PROJECT: Skye Canyon Neighborhood Park

SUBMITTAL: Supplement

CITY OF LAS VEGAS		DATE:
INTER-OFFICE MEMORANDUM		June 4, 2015 
TO: Land Development Services Department of Building & Safety		FROM: Albert Sung, P.E. Flood Control Project Engineer Department of Public Works
SUBJECT:	Drainage Study for:	COPIES TO:
	Skye Canyon Neighborhood Park	Slater Hanifan Group
Cross Streets:	SWC Eagle Canyon Av & Mountain Landing St	Ninety-Five Management LLC
File Number:	F:\Depot\DSMemos\DS4721B.doc	Bart Anderson, P.E., DevCo
Parcel Number:	125-07-410-001	CCRFCD
Zoning Action:	FMP-57264; SDR-58930	
FEMA Flood Zone	YES NO X	
Proposed Storm Drain	YES NO X

**Subject: Supplement No. 1 to the Technical Drainage Study for
Skye Canyon Neighborhood Park (DS4721A)**

NINETY-FIVE MANAGEMENT, LLC.
SKYE CANYON - PHASE 1 INFRASTRUCTURE
DEVELOPED CONDITION DRAINAGE MAP

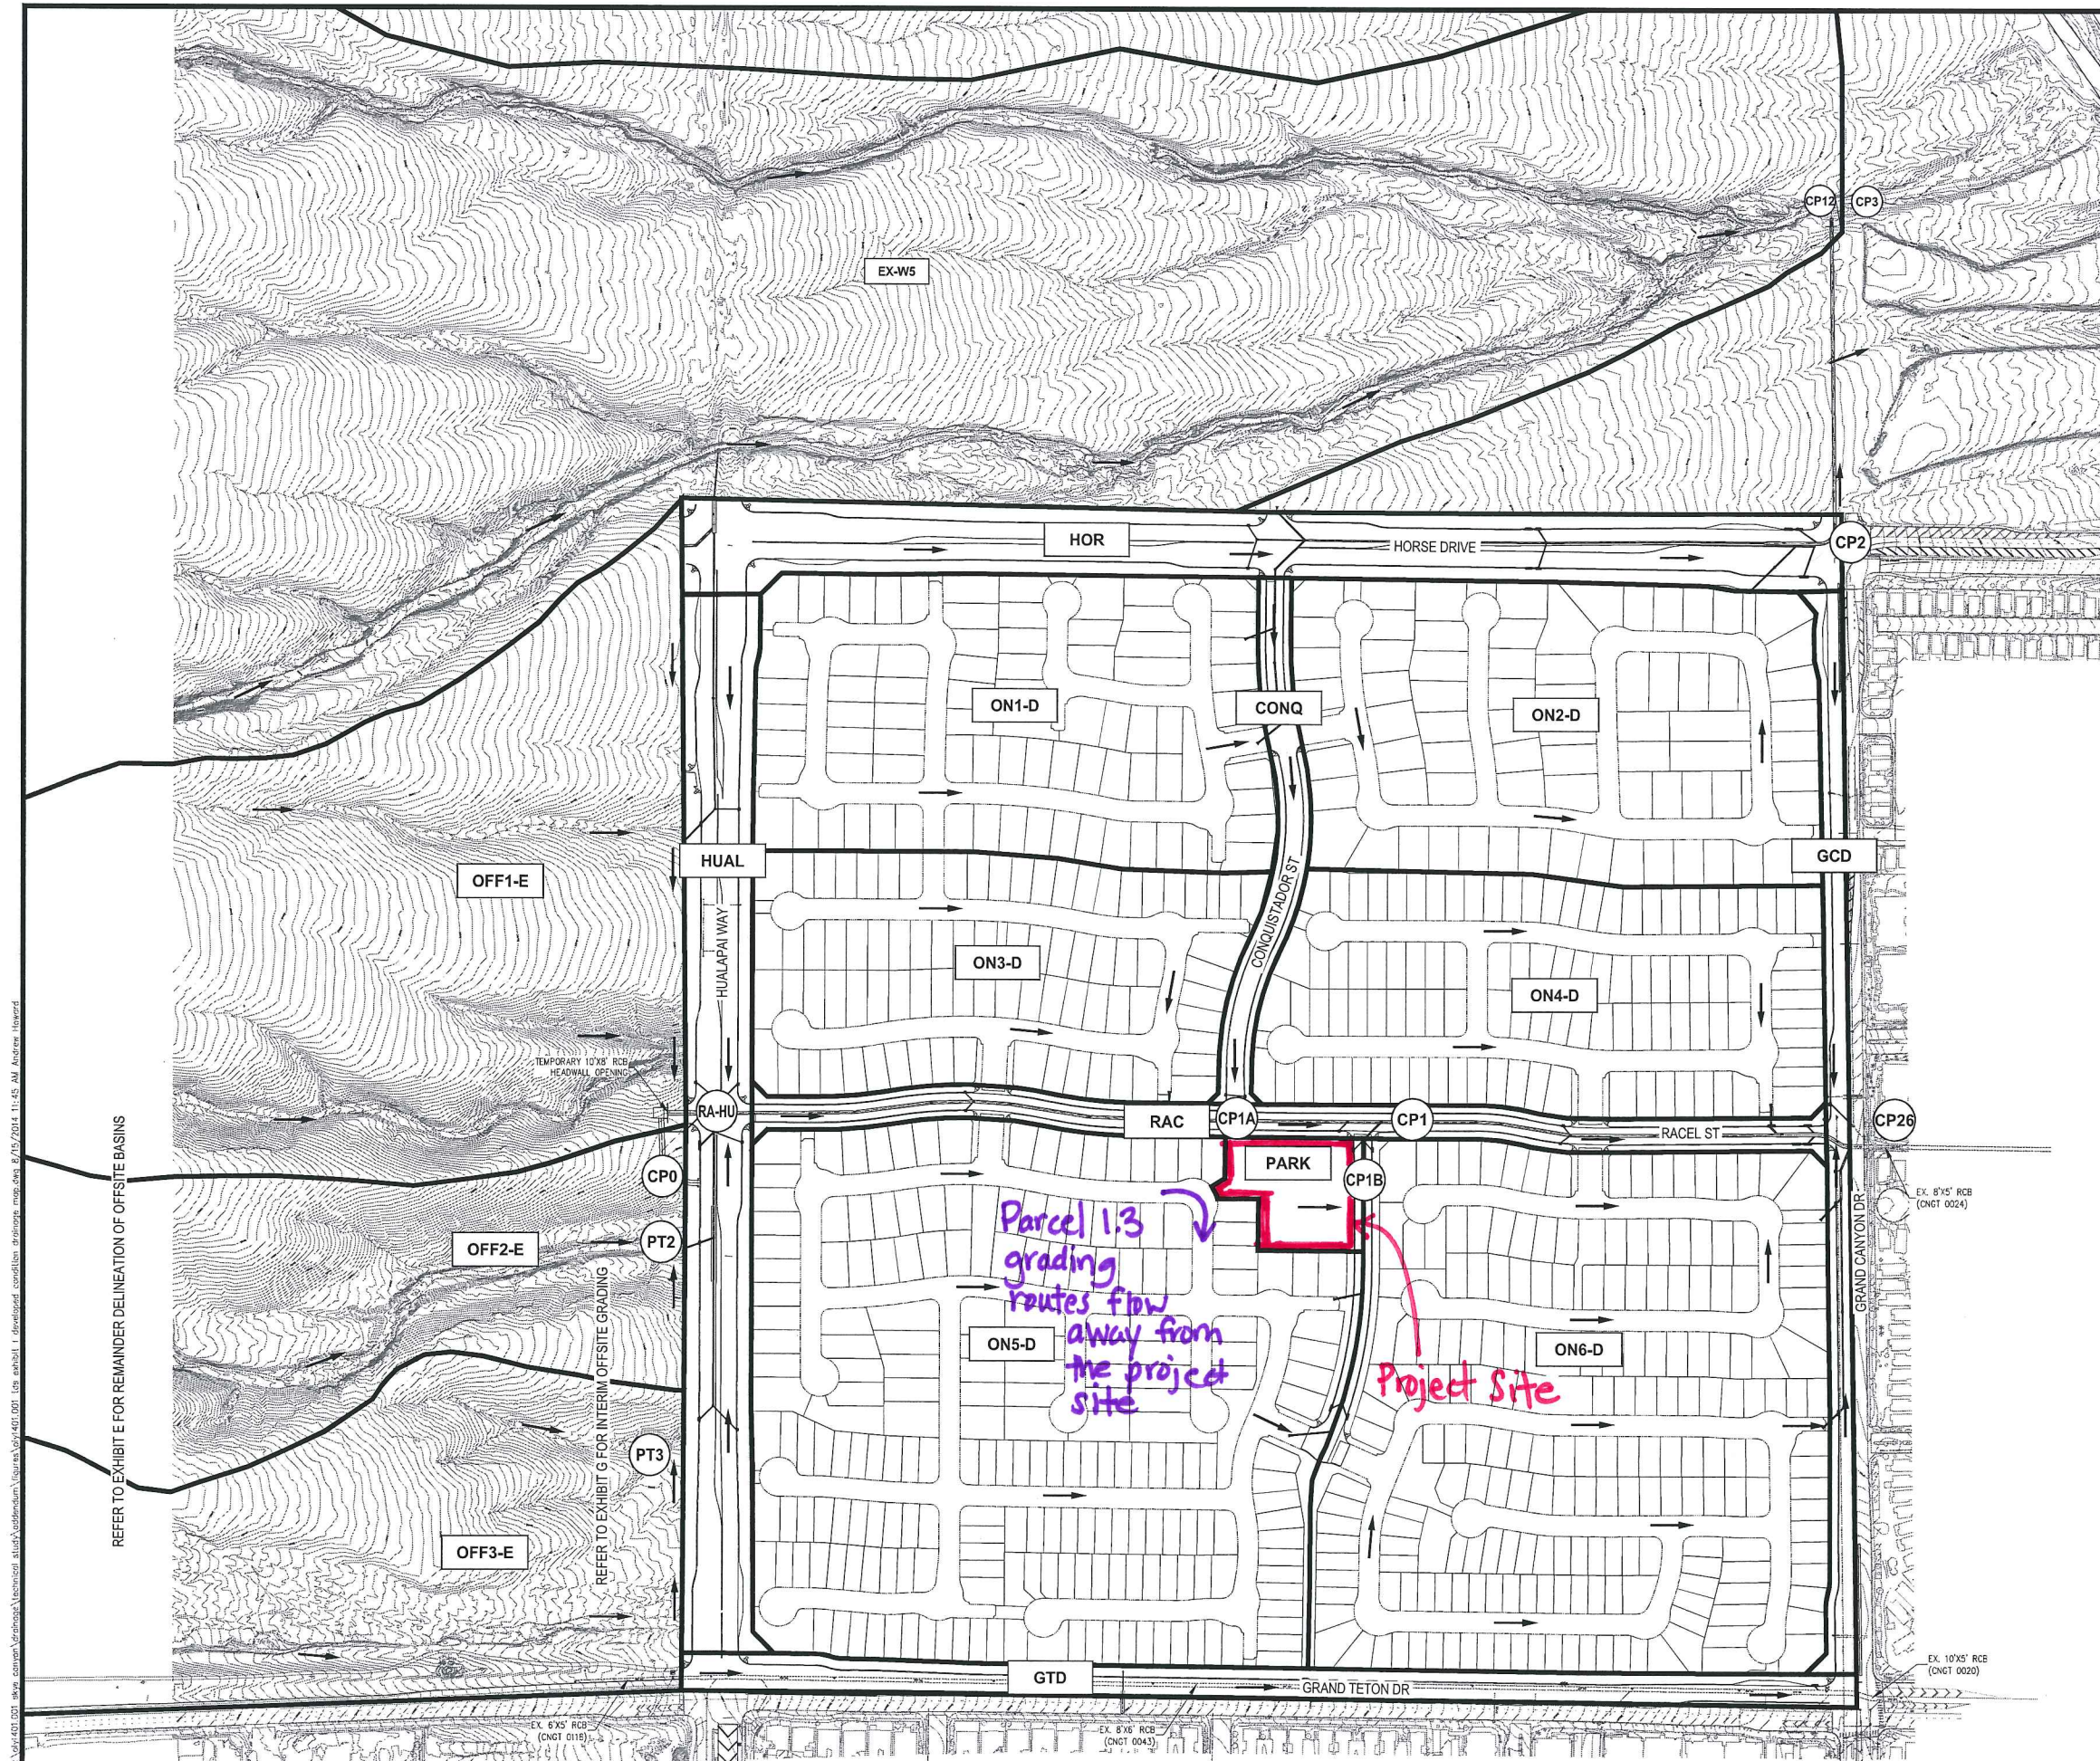
2. **Comment:** *The subject drainage study is based on the condition that the Skye Canyon Phase 1 Infrastructure and the perimeter streets (Eagle Canyon Avenue and Mountain Landing Street) are fully improved for onsite major storm events protection. The perimeter streets and all the associated storm drain facilities must be completed prior to the issuance of building permits for the subject development;*

Response: Upon review of the Skye Canyon Phase 1 Infrastructure hydrology, the following has been determined:

- The historical offsite flows impacting the subject site is limited to a small area to the west, estimated at approximately 1.5 acres. The subject site is generally not impacted by any flows from the north or south. Note that the subject site is located to the north and outside of a well-incised wash draining in an easterly direction. Refer to referenced Exhibit E, provided in Appendix B, for the subject site location and the surrounding historical drainage pattern.
- The Phase 1 Infrastructure improvements do not flood protect the subject site from the approximate 1.5-acre offsite watershed nor does it alter the offsite watershed. Refer to referenced Exhibit G, provided in Appendix B, for the subject site location and the surrounding Phase 1 Infrastructure drainage pattern.

- The Skye Canyon Parcel 1.3 grading does serve as flood protection for the subject site because it routes the approximate 1.5-acre offsite watershed south and away from the subject site. Refer to referenced Exhibit F, provided in Appendix B, for the subject site location and the Skye Canyon Phase 1 drainage pattern.

With Phase 1 Infrastructure improvements not serving as flood protection for the subject site, it is warranted that the building permit for the subject development can be issued prior to the completion of the perimeter streets (Eagle Canyon Avenue and Mountain Landing Street) associated with the Phase 1 Infrastructure. Additionally, it should be noted that Phase 1 of Skye Canyon Parcel 1.3 has been mapped, the grading plans are approved and the grading permits have been issued. The approved Skye Canyon Parcel 1.3 Phase 1 improvement plans have been provided in Appendix C for reference. The mapping, approval and grading permit issuance demonstrates the construction movement of Parcel 1.3 that serves as flood protection; therefore, the building permit for the subject development can be issued without any conditions.
